## **Metro North-West Joint Development Assessment Panel Agenda**

<b>8.1</b>	Property Location:	Lots 104 and 105 (8 and 10) Brechin Court, Duncraig
	Development Description:	16 Multiple Dwellings
	Applicant:	Harden Jones Architects
	Owner:	Mr Heinrich Arnoldus Kuenen
	Responsible Authority:	City of Joondalup
	DAP File No:	DAP/19/01557

<b>Property Location:</b>	Lots 104 and 105 (8 and 10) Brechin Court, Duncraig
<b>Development Description:</b>	16 Multiple Dwellings
<b>DAP Name:</b>	Metro North-West JDAP
<b>Applicant:</b>	Harden Jones Architects
<b>Owner:</b>	Mr Heinrich Arnoldus Kuenen
<b>Value of Development:</b>	\$2.45 million
<b>LG Reference:</b>	DA18/1389
<b>Responsible Authority:</b>	City of Joondalup
<b>Authorising Officer:</b>	Dale Page, Director Planning and Community Development
<b>DAP File No:</b>	DAP/19/01557
<b>Report Due Date:</b>	10 July 2019
<b>Application Received Date:</b>	18 December 2018
<b>Application Process Days:</b>	90 Days
<b>Attachment(s):</b>	1: Location plan 2: Development Plans and Elevations 3: Building Perspective 4: Context plans 5: Shadow diagram 6: Landscape Plan 7: Solar access and cross ventilation diagrams 8: Waste Management Plan 9: Transport I

Title:  
Deep Soil Root Plan Zone

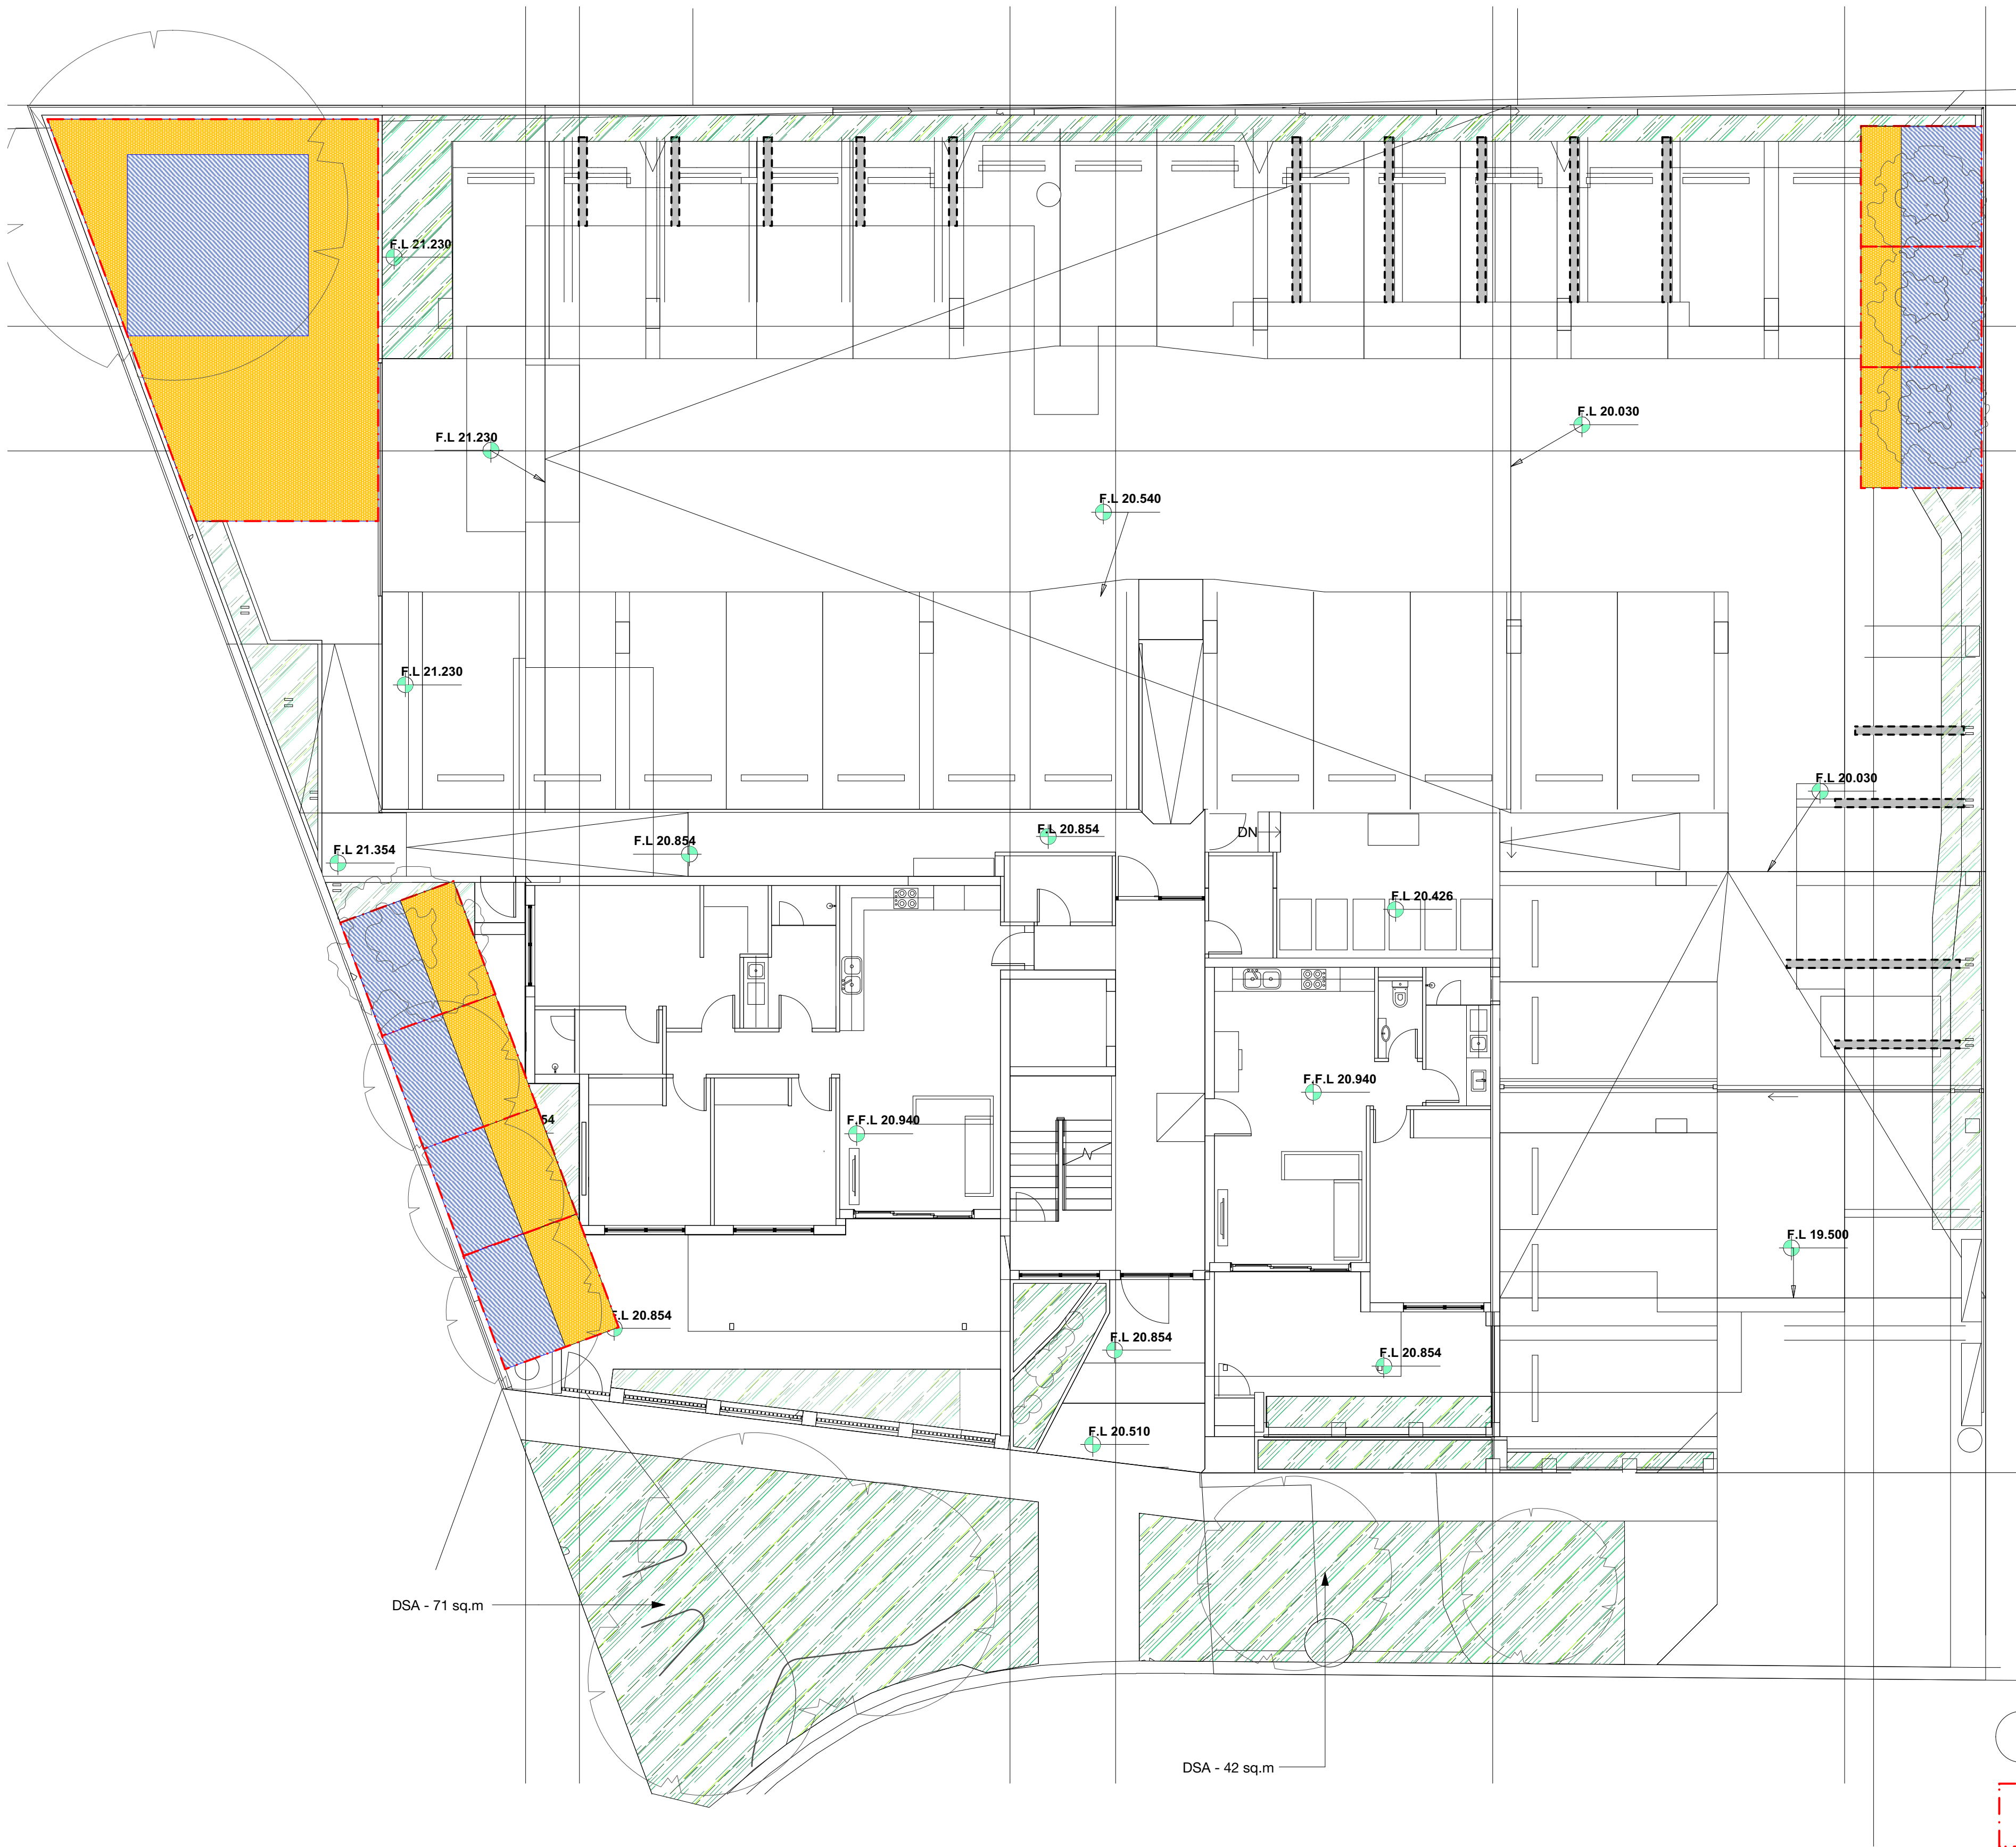
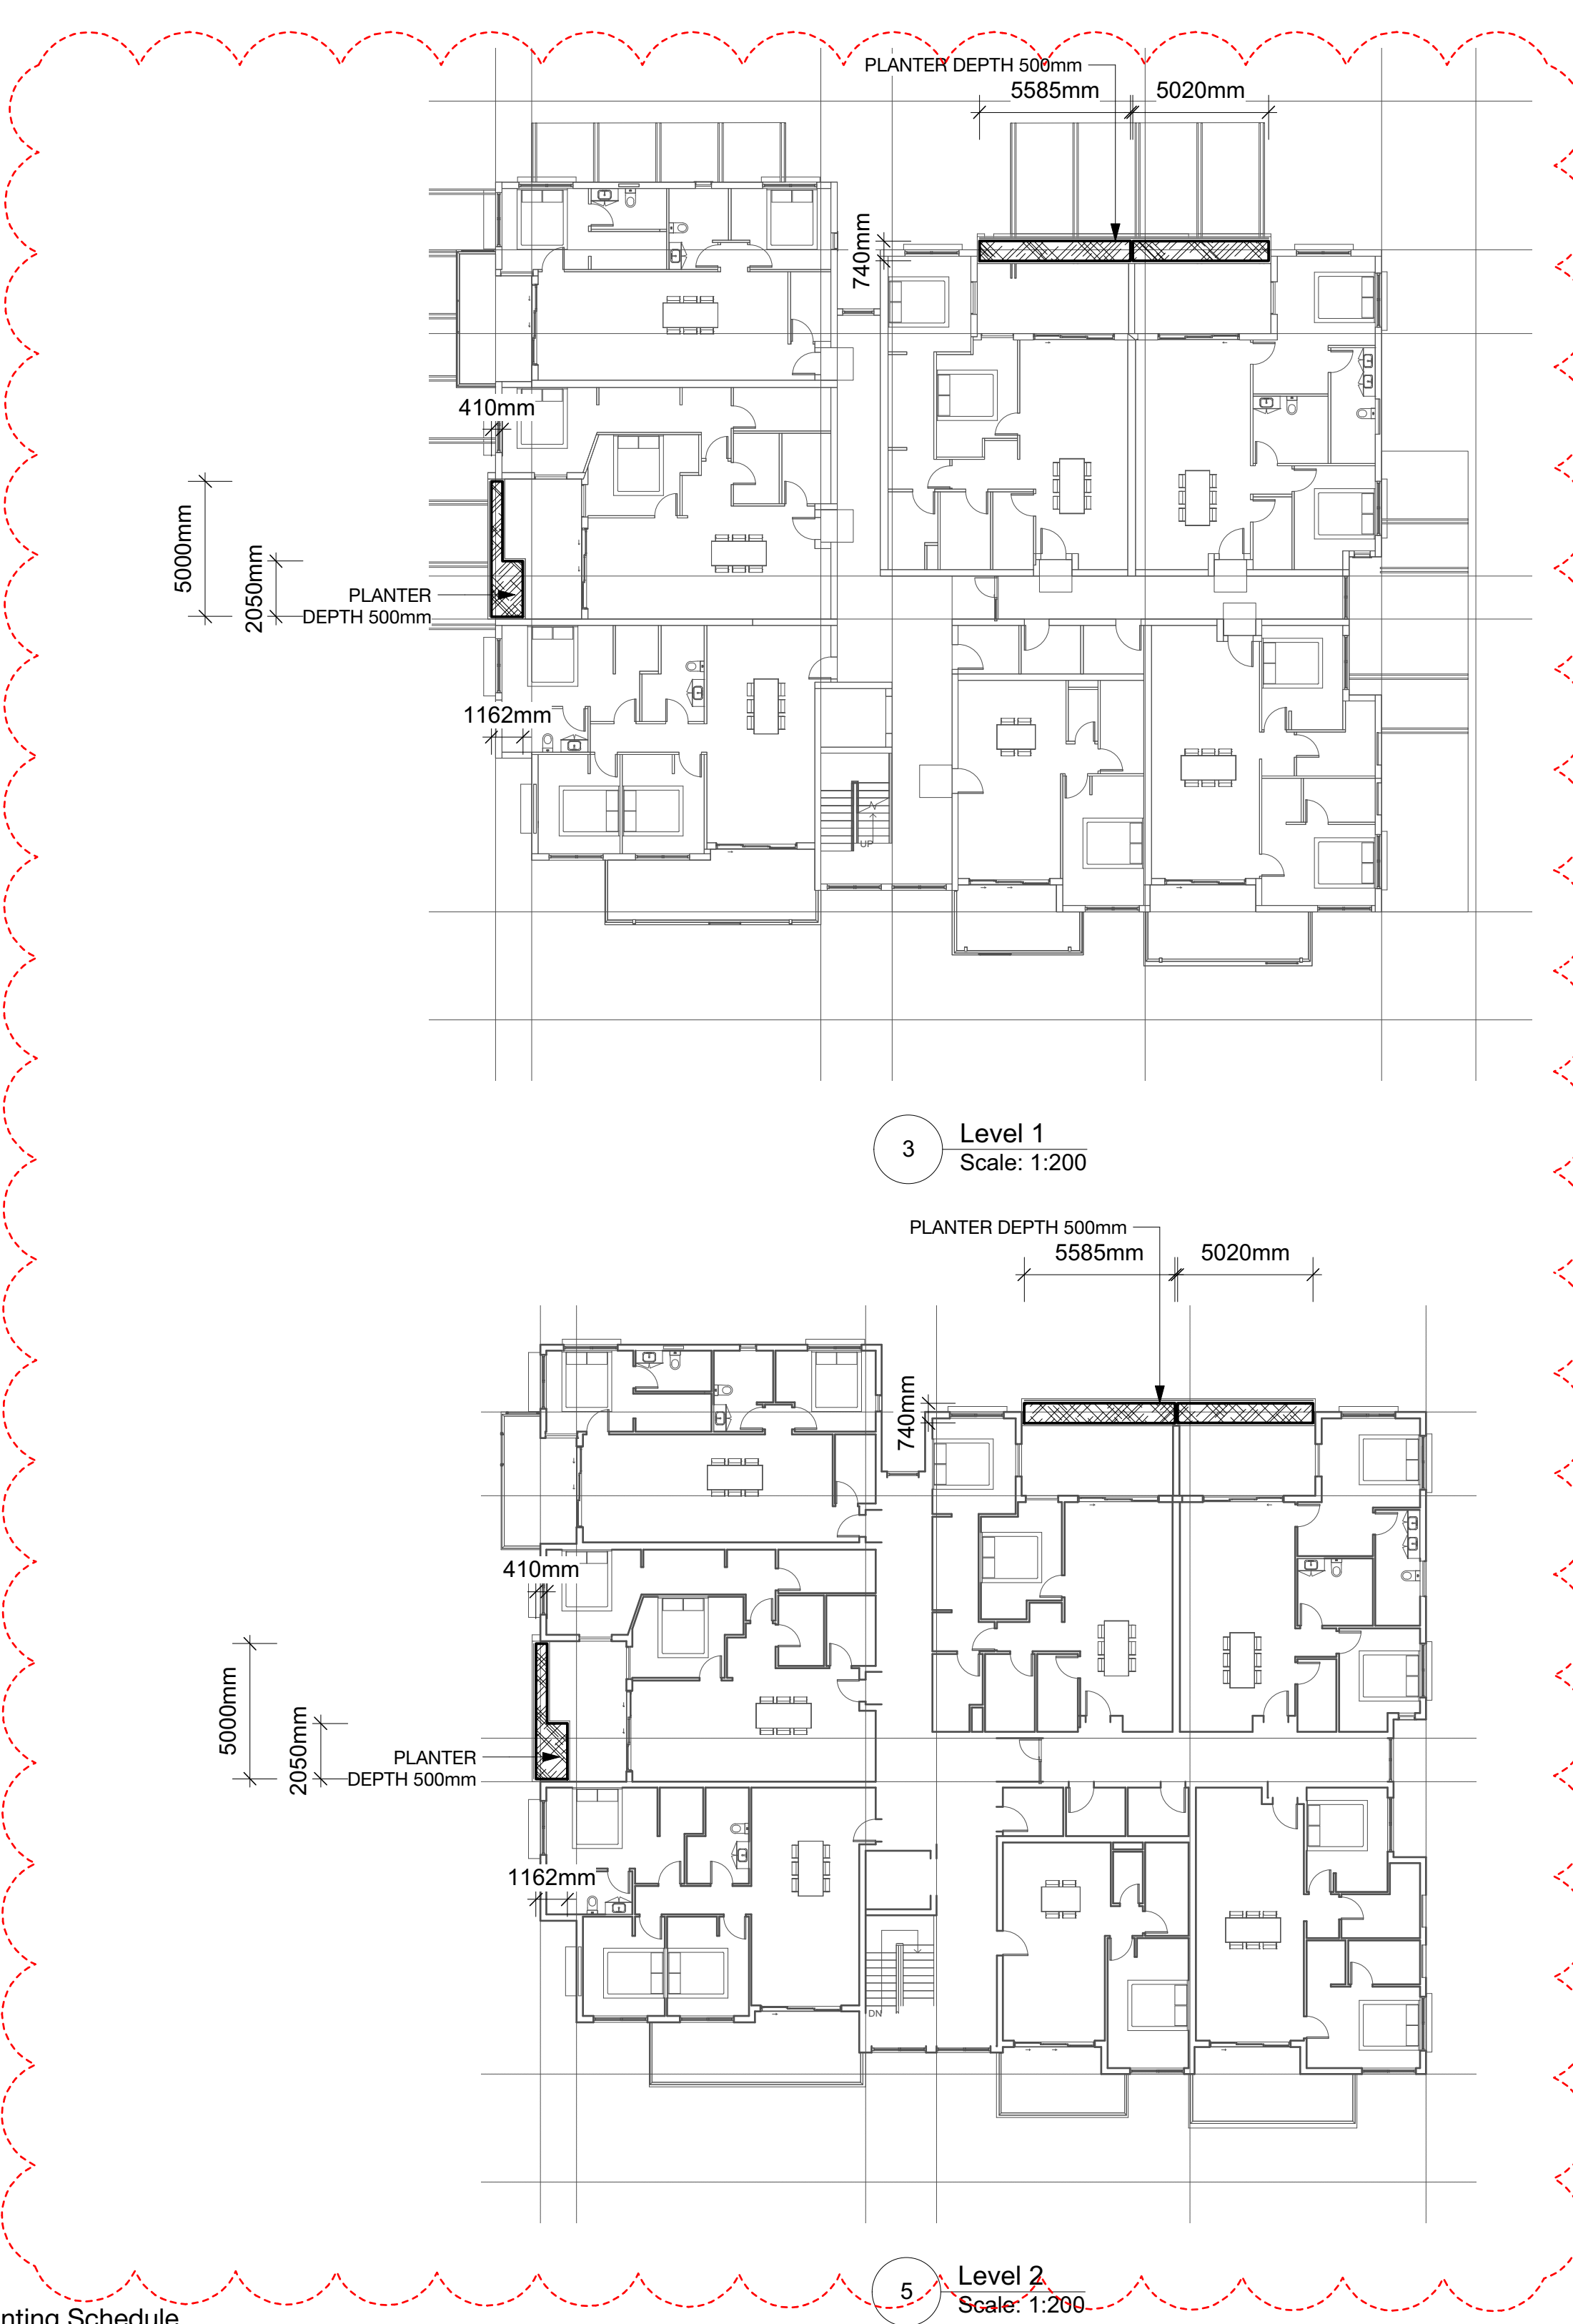
The proposal does not result in the loss of significant trees, will not result in undue canopy loss of adjoining trees and provides adequate deep soil area. The proposal however does not provide the required trees with shade producing canopies. The proposal provides 1 medium tree and 3 small trees across the site.

3. SECOND FLOOR  
1 : 100

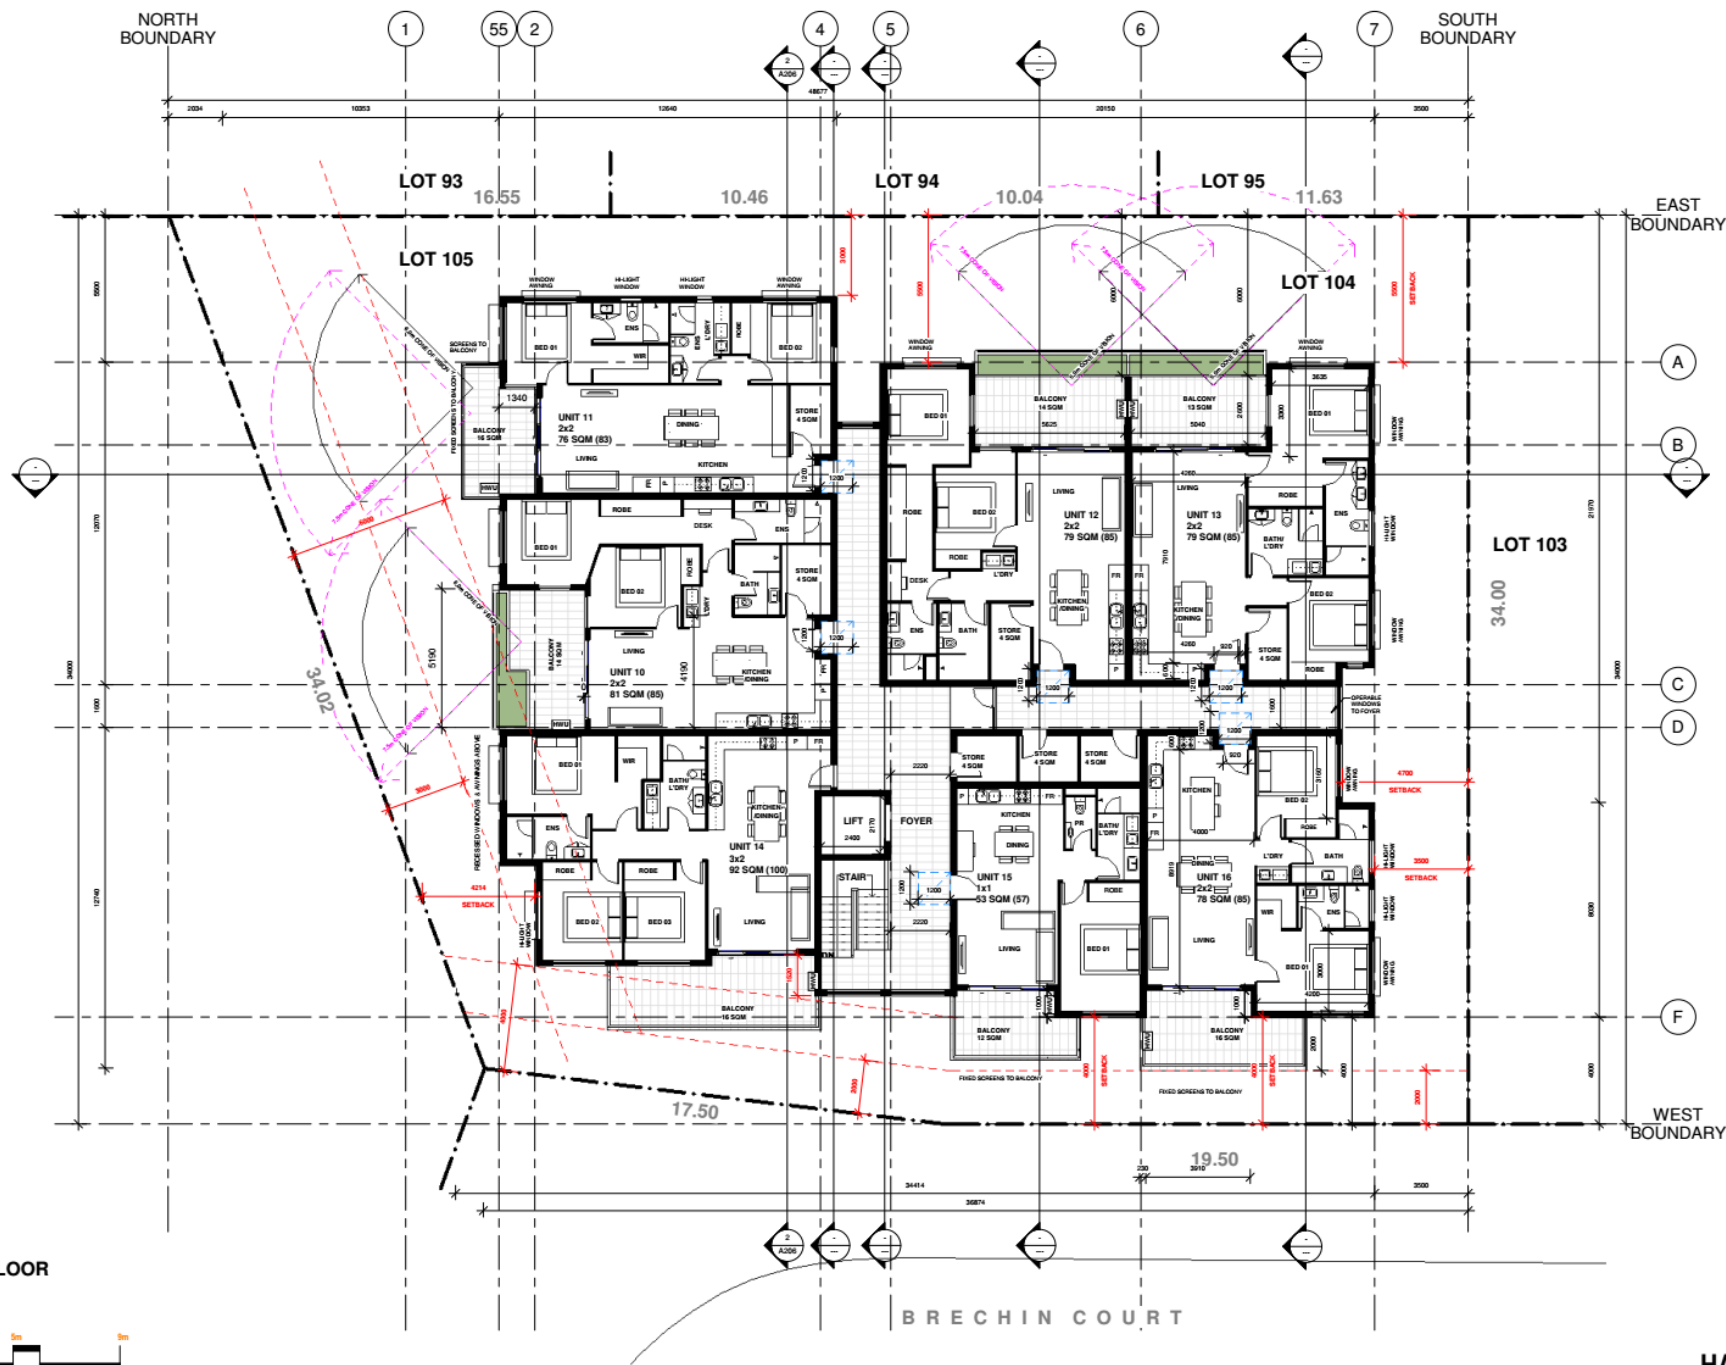
TOTAL BALCONY LENGTH IN  
FRONT SETBACK: 19.50M  
51% IN LIEU OF 50%
